Xcheng Communication Technology Co.,Ltd

MODEL: D0231

TITLE: D0231_SECOND_LCD

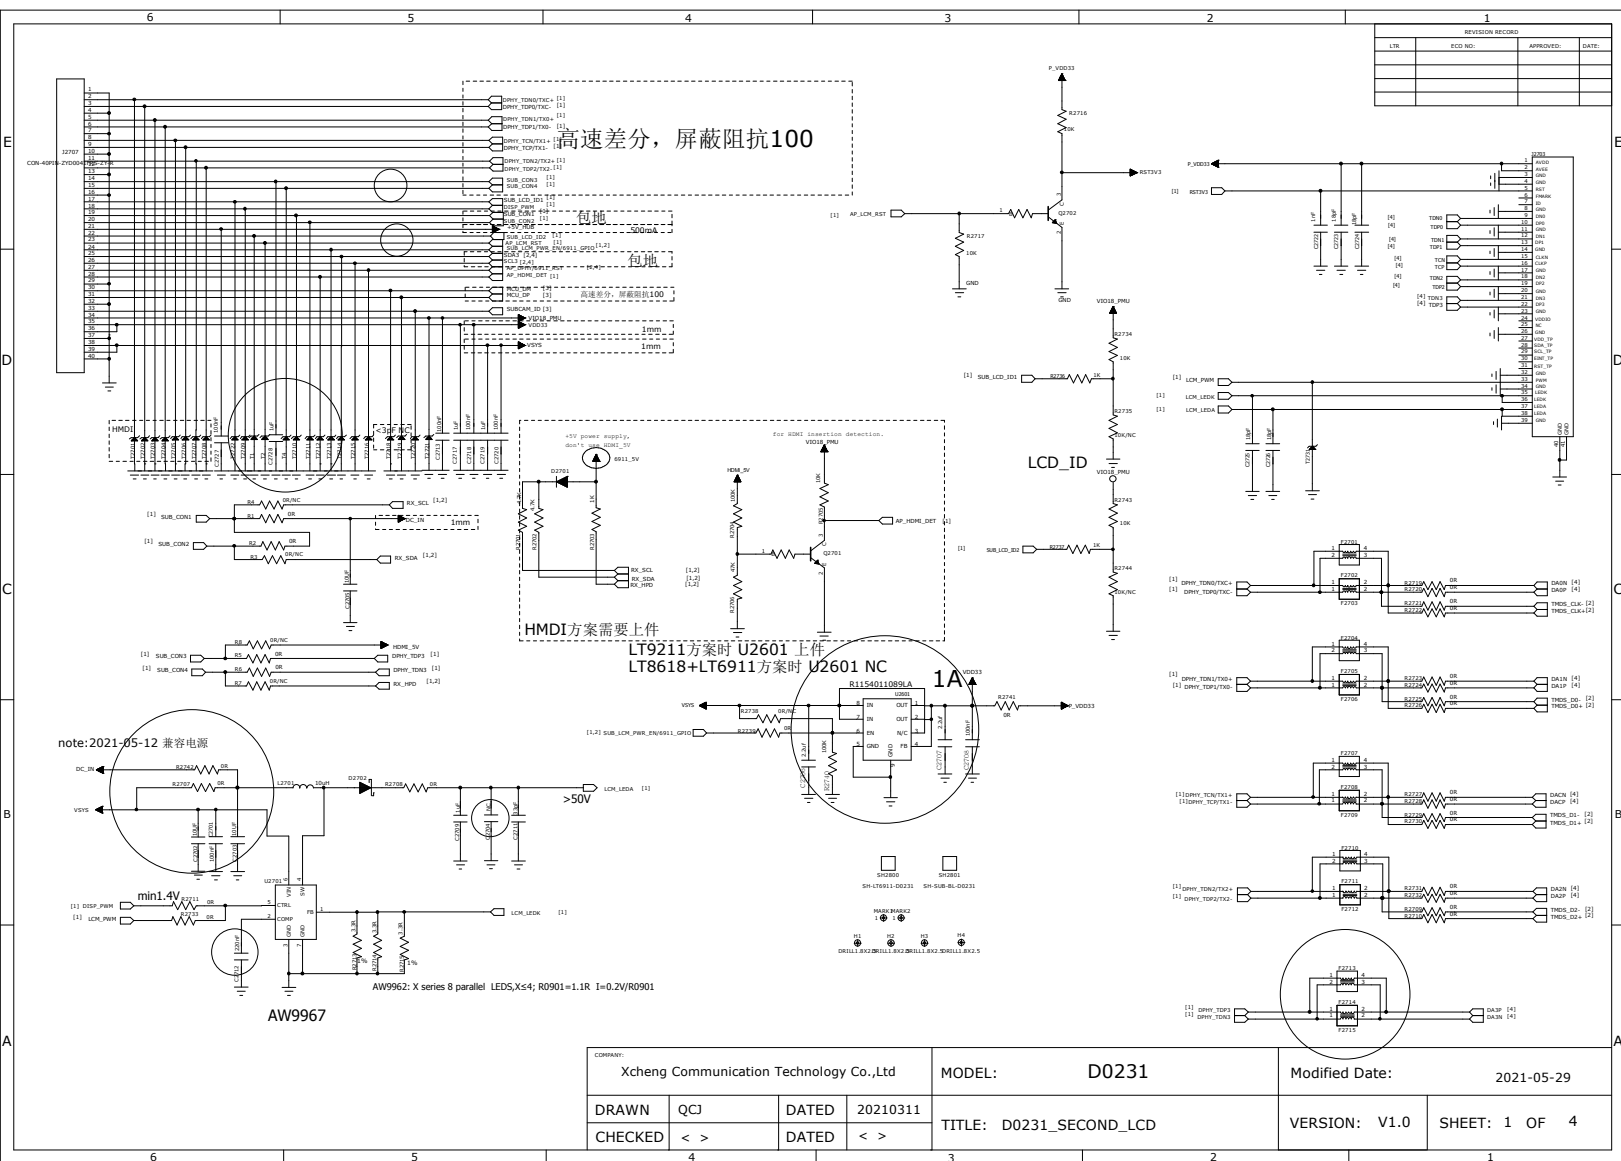
note:2021-05-12 删除

note:2021-05-12 删除HDMI方案，增加MIPI延长

MIPI延长
